Access Compliance Report Public Rights-of-Way (Curb Ramps)

Main Street: CECIL_PASTURE_RD Cross Street: WESTCOTT_LN Location: SW

ADA ID: RPRK211026125203 Ramp Type: Type 1 - Perpendicular Initial Pass/Fail: Fail Overall Compliance: No Severity Score: 15

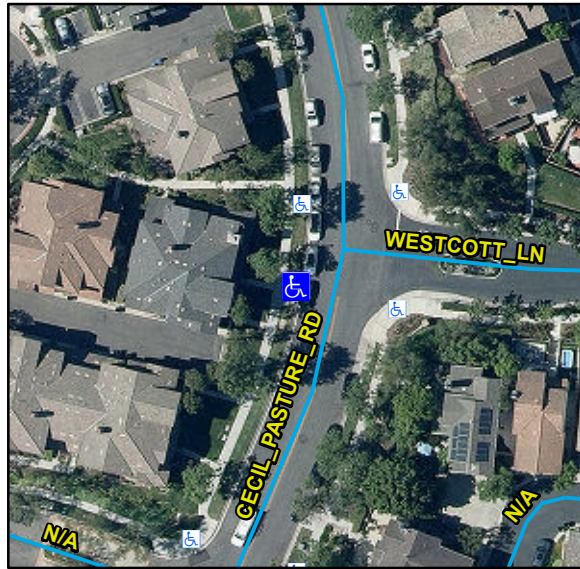
Compliance	Description	Data	Compliance	Description	Data
N/A	Ramp Length (in)	90	N/A	Flare Type LT	
Yes	Ramp Width (in)	48			N/A
No	Ramp Run Slope (%)	8.5	N/A	Flare Slope LT (%)	N/A
Yes	Ramp Cross Slope (%)	2.1	N/A	Flare Traversable LT	N/A
N/A	Landing Present	N/A	N/A	Flare Type RT	
N/A	Landing Length (in)	N/A			N/A
N/A	Landing Width (in)	N/A	N/A	Flare Slope RT (%)	N/A
N/A	Landing Run Slope (%)	N/A	N/A	Flare Traversable RT	N/A
N/A	Landing Cross Slope (%)	N/A	N/A	DWS Provided	N/A
N/A	Landing Movement Obstructed?	N/A	N/A	DWS Contrast	N/A
	Landing Movement Type	N/A	N/A	DWS Length (in)	N/A
N/A	Landing Shared	N/A	N/A	DWS Full Width	N/A
N/A	Clear Space	N/A	N/A	DWS Offset Left (in)	N/A
N/A	Clear Space To Crosswalk (in)	N/A	N/A	DWS Offset Right (in)	N/A
N/A	Marked Crosswalk 1	No	N/A	Marked Crosswalk 2	N/A
	Crossing 1 Direction	SE		Crossing 2 Direction	N/A
	Marked Crosswalk 1 Width (in)	N/A		Marked Crosswalk 2 Width (in)	N/A

Remove & Replace Entire Ramp.
